Village of Winnetka

Design Review Board/Sign Board of Appeals Regular Meeting

November 21, 2024 at 7:00 PM
Winnetka Village Hall Council Chambers
510 Green Bay Road

933 GREEN BAY RD. WINNETKA, IL. - NEW RETAIL BUILDING DESIGN REVISIONS 11.11.24

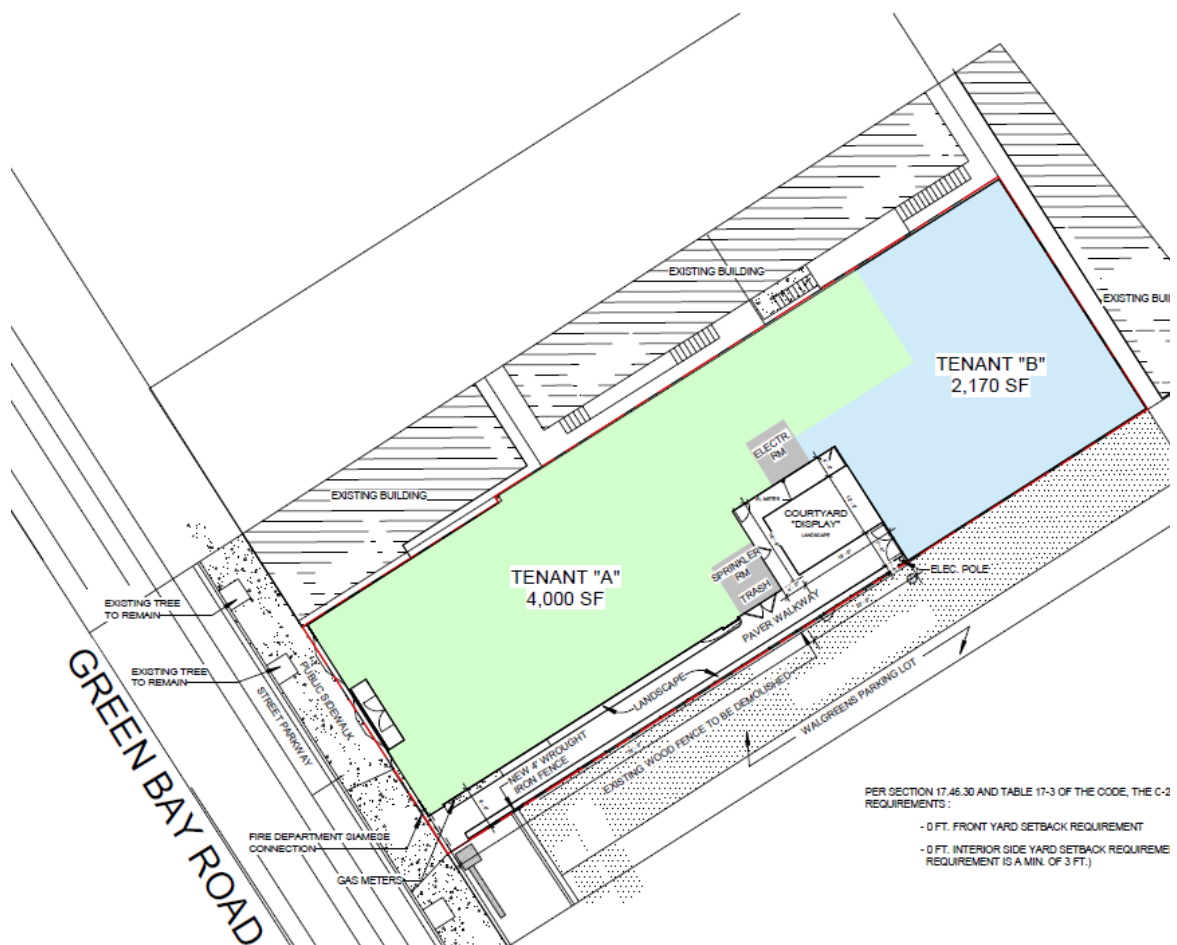
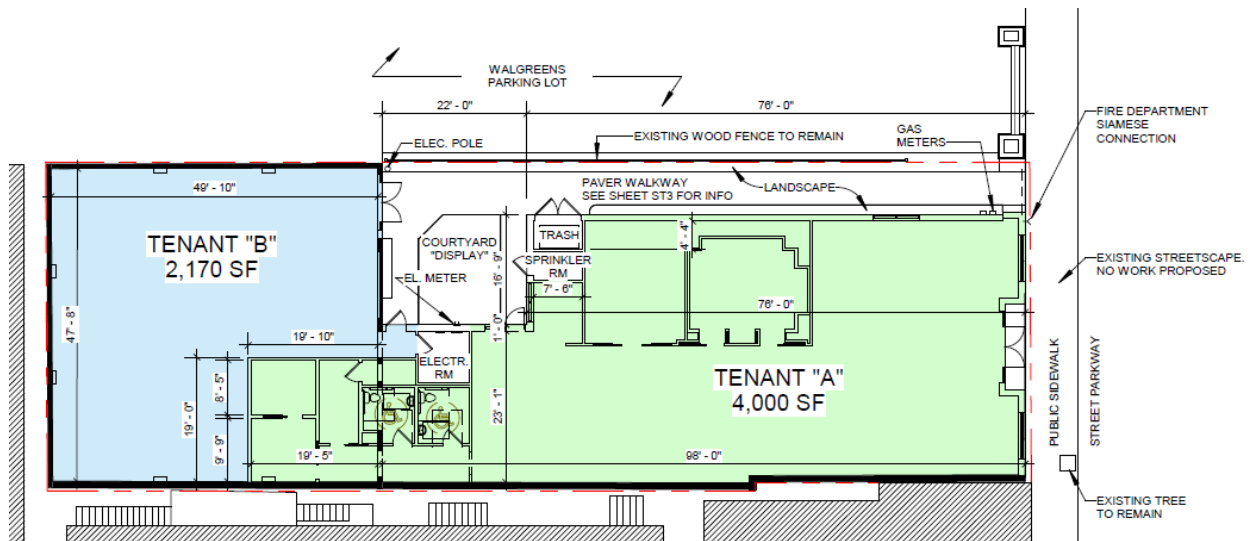
In response to comments at the October 17 DRB meeting, the Applicant has provided the attached written explanation describing the revised design and plans (**Attachment A1**). The primary changes include the following:

- Revised brick color to red to be more compatible with existing buildings on the block and painting existing brick red to match.
- Use of natural Indiana limestone for building base, banding, parapet coping, and trim.
- Removal of faux second floor windows, and increased height of storefront framing, glass and entry.
- Revised design to include and highlight natural limestone detailing on pilasters.
- Revised design to include additional pilaster near the rear of the building to balance south elevation.
- Revised courtyard design, including enlargement of landscape area.
- New 4-foot-tall black wrought iron fence.

- A) REVISE BRICK COLOR FOR MORE COMPATIBLE APPEARANCE WITH EXISTING BUILDINGS ON THE BLOCK
- B) REVISE TO NATURAL INDIANA LIMESTONE FOR BUILDING BASE, BANDING, PARAPET COPING, & TRIM
- C) REMOVE '2 ND FLOOR' WINDOWS, INCREASE HEIGHT OF STOREFRONT FRAMING, GLASS, AND ENTRY
- D) REVISE DESIGN TO INCLUDE AND HIGHLIGHT MORE NATURAL LIMESTONE DETAILING ON 'PILASTERS'
- E) REVISE DESIGN TO INCLUDE ADD'L PILASTER NEAR REAR OF BUILDING TO BALANCE SOUTH ELEVATION
- F) REVISE DESIGN TO INCLUDE A STEP AT FRONT ENTRY BECAUSE OF SITE GRADING / ADA COMPLIANCE
- G) REVISE COURTYARD DESIGN, ENLARGE LANDSCAPE AREA TO COORDINATE & MEET ADA COMPLIANCE
